# CITY OF FLAGSTAFF
# STAFF SUMMARY REPORT

**TITLE: PCSUB08-003, a request for Preliminary Plat approval for Mr. Joseph Kavanagh's "Peaks Plaza Condominiums", a .62 acre, mixed-use subdivision located at 1819 E. Second Avenue in the C-2-E, Commercial District Established.**

**DEVELOPMENT SERVICES DIVISION**
**PRELIMINARY PLAT REPORT**

**PC SUB 08-003**

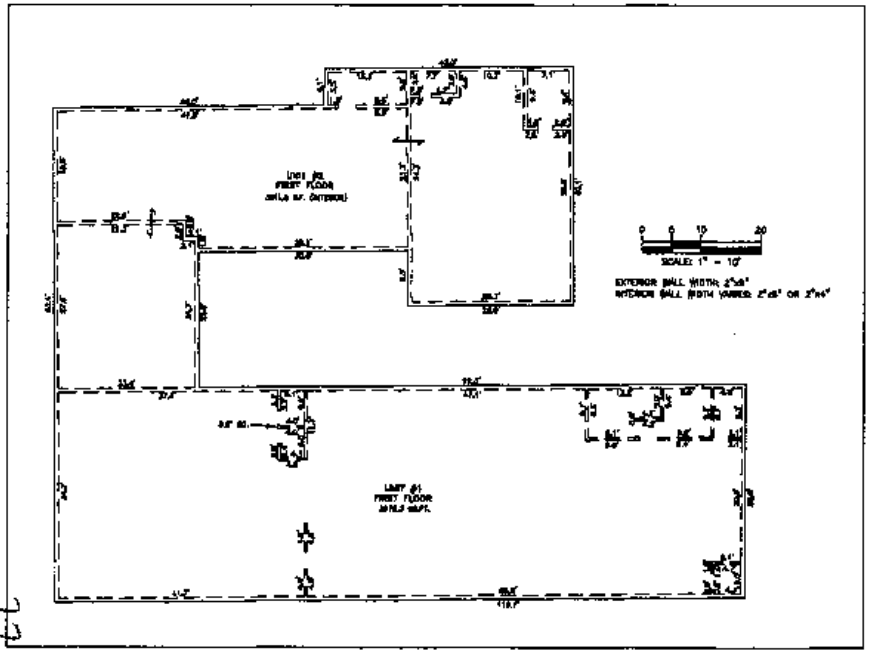
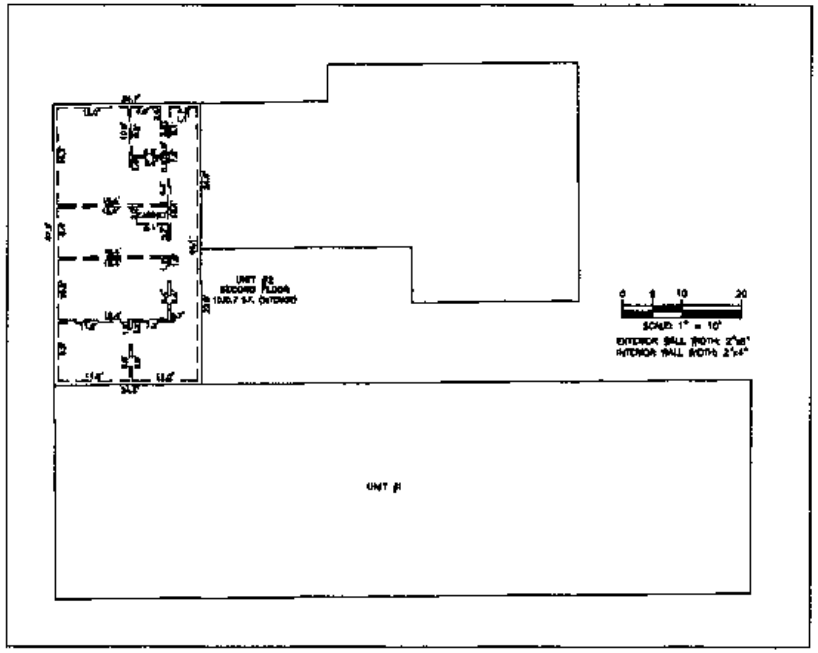
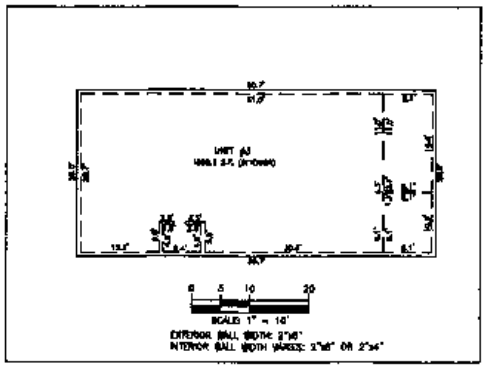
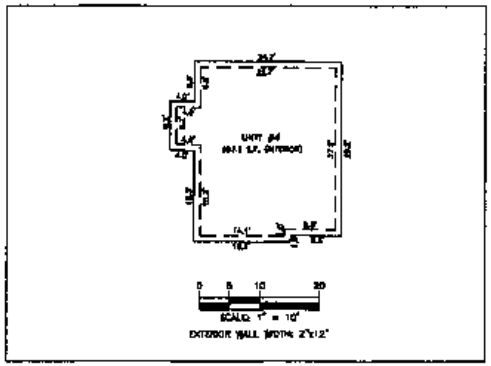
1. Any non-approved, non-conforming light fixtures shall be in compliance prior to final plat approval.
2. Applicant has now indicated that windows closer than 3' are to be "sealed" (reference Building #1, east elevation). Sealing must mean blocking in and providing a rated closure. Prior to obtaining a certificate of occupancy, the owner must submit for a tenant improvement project and provide the necessary separations. The 2006 IBC codes both require a two-hour separation (B occupancy for offices and A-3 occupancy for the private gym). There shall be a 2 hour fire barrier between the U Occupancy and B occupancy and 1 hour from the A-3 occupancy.

PEAKS PLAZA CONDOMINIUMS
LANDSCAPE PLAN
PRELIMINARY PLAT

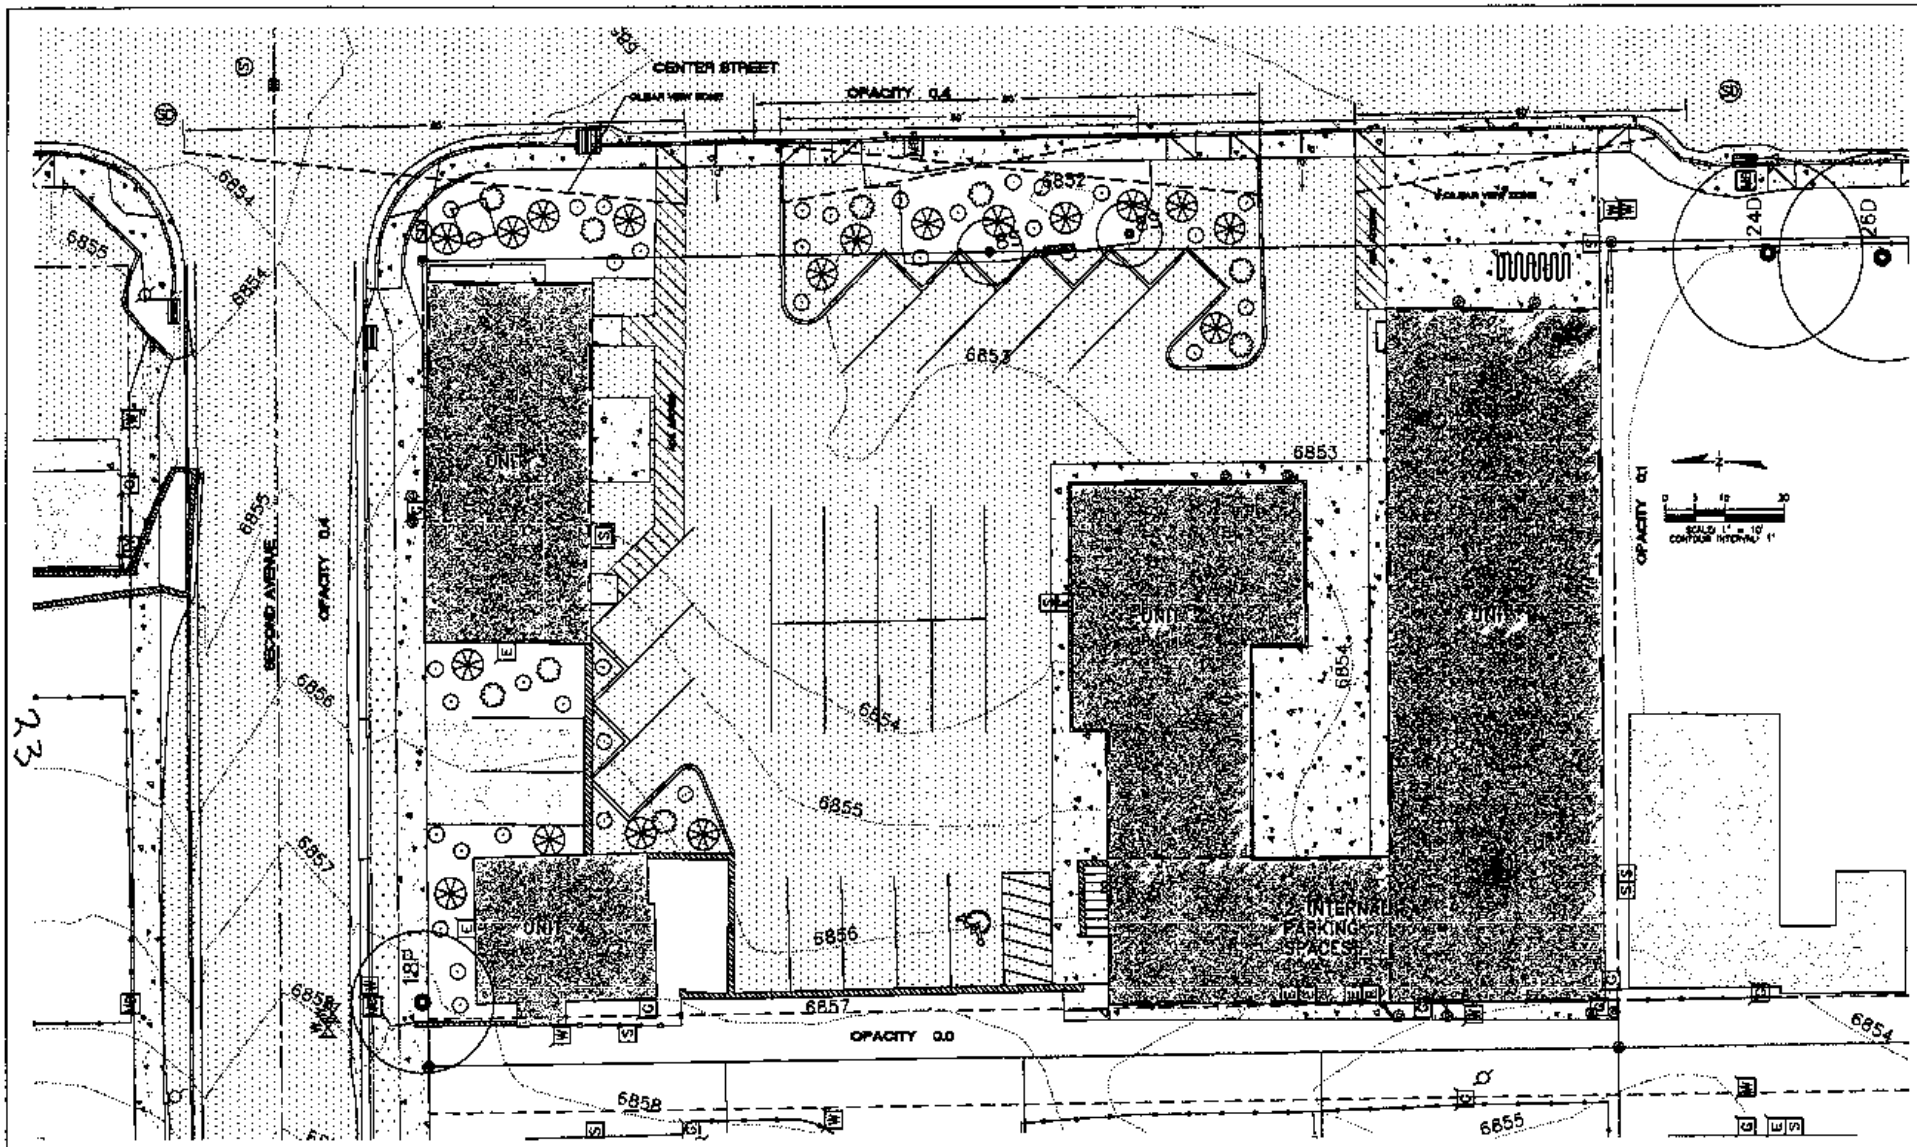
2. Landscaping:
   - Remove concrete drive located in the right-of-way that previously served the gym. Landscape according to bufferyard standards which shall bring the plant units to the required plant unit amount.

- Due to sign relocation requirement listed in number one (1) above, provide appropriate landscaping around the monument sign.
   - Update and make corrections on landscape plan and submit with P & Z application
